URBAN DESIGN COMMISSION APPLICATION CITY OF MADISON

1. Project Address: 200 South Pinckney Street (Block 88 & 105)
Project Title (if any): Judge Doyle Square

200 South Pickney Street (Block 88 & Block 105) – Judge Doyle Square Revised UDC Package

JUDGE DOYLE SQUARE - BLOCKS 88 AND 105 SUPPLEMENTAL DRAWING PACKAGE SUBMITTAL

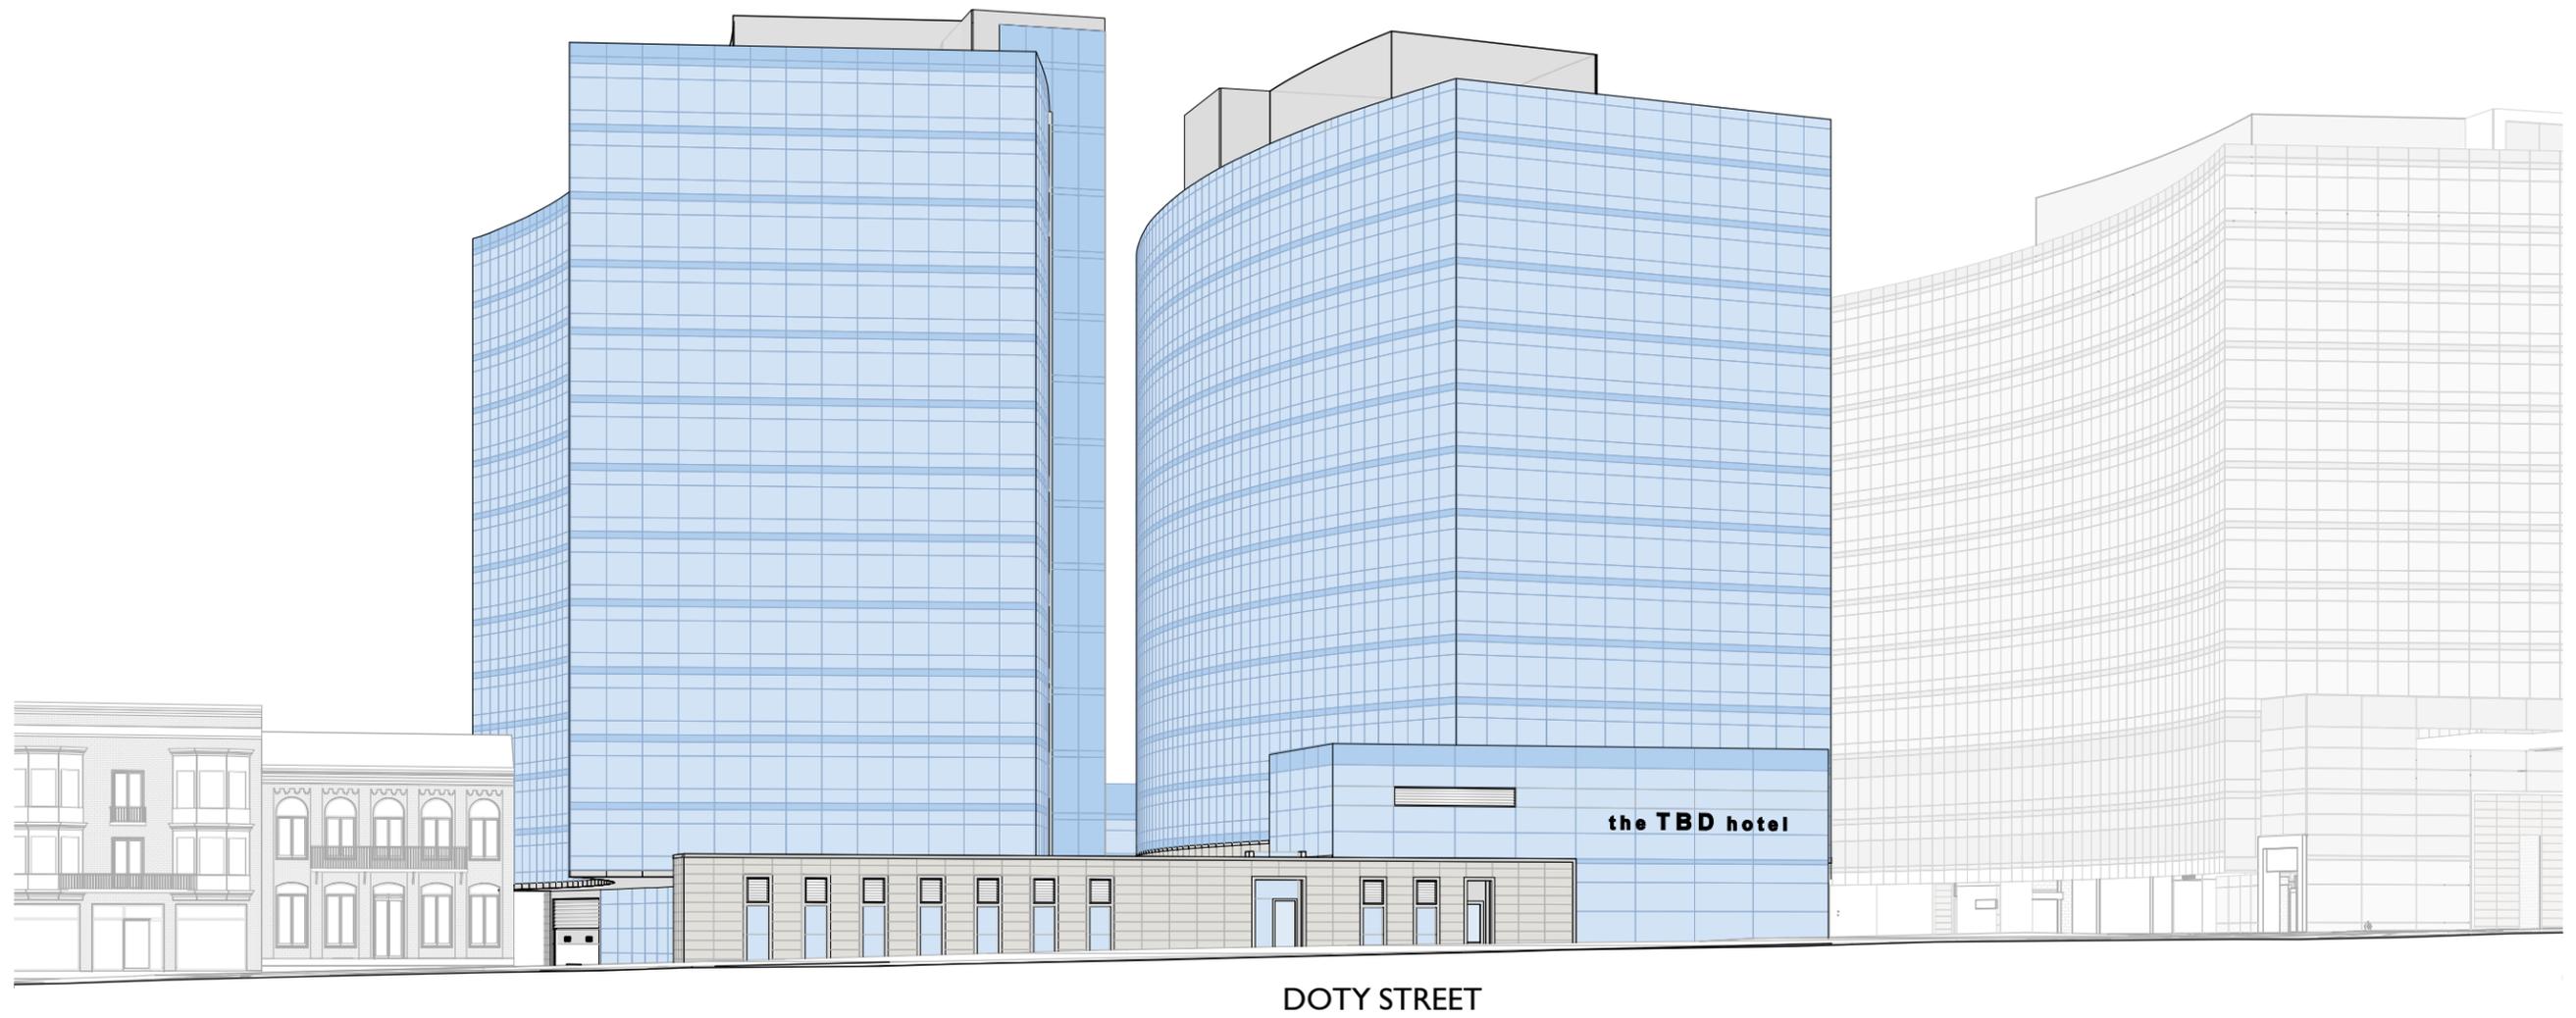
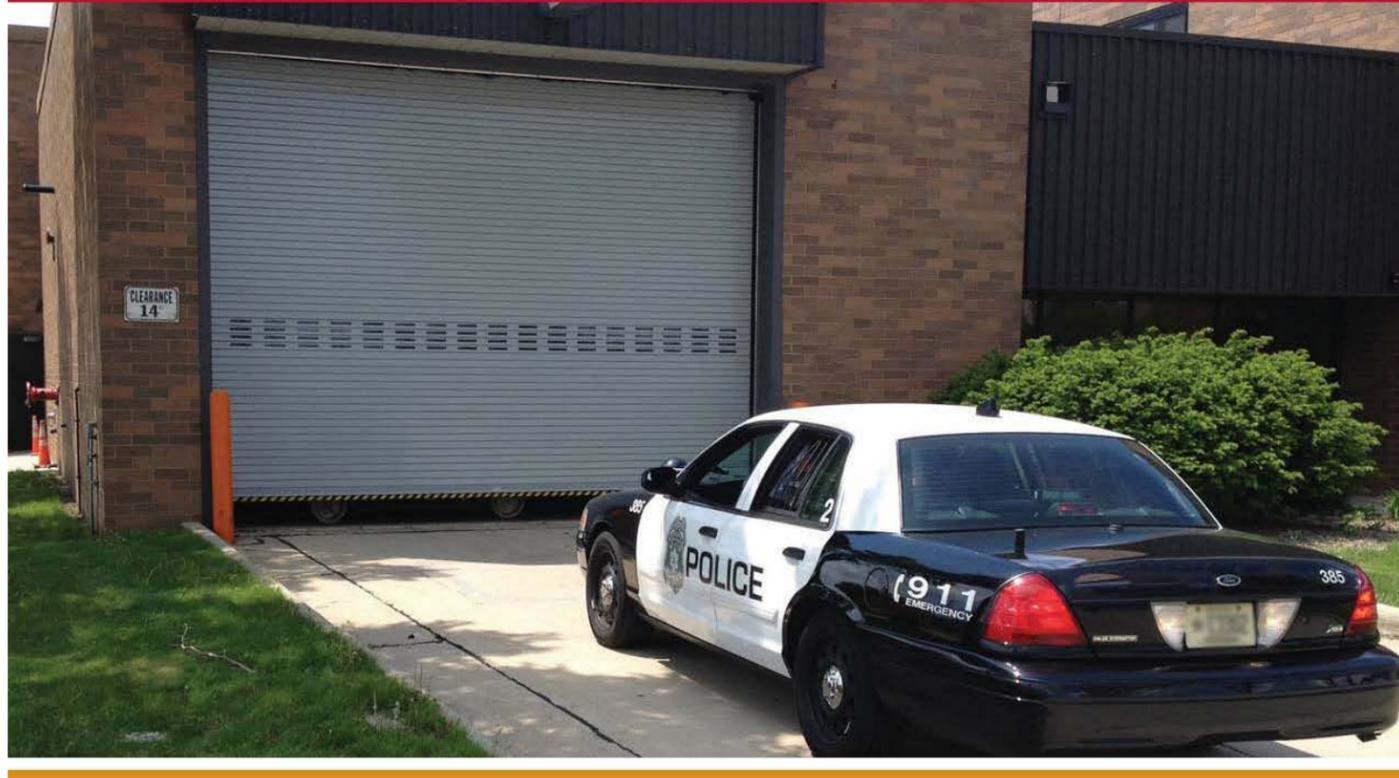
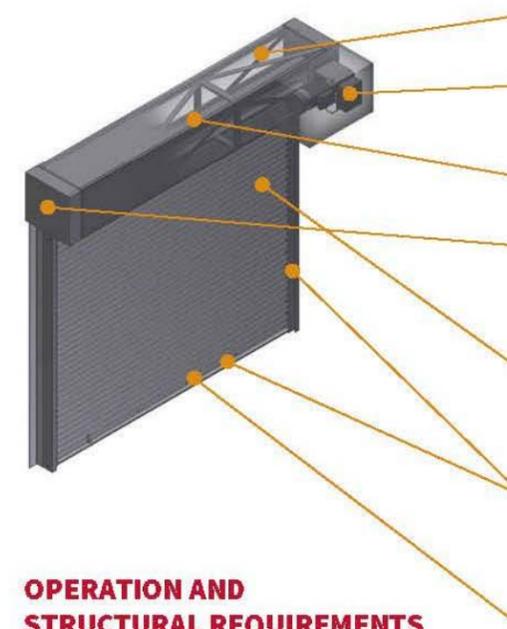
- 74) That details on all garage doors on Blocks 88 and 105 be provided and approved by the Urban Design Commission and staff.
The details of the garage doors are outlined on page 4-01B.

- The overhead doors for loading docks be brought out to the building façade. Material details for these doors shall be provided.

The overhead doors for loading have been relocated as outlined on pages 2-06 and 3-04. Door Cut Sheet has been provided on Sheet 4-01B
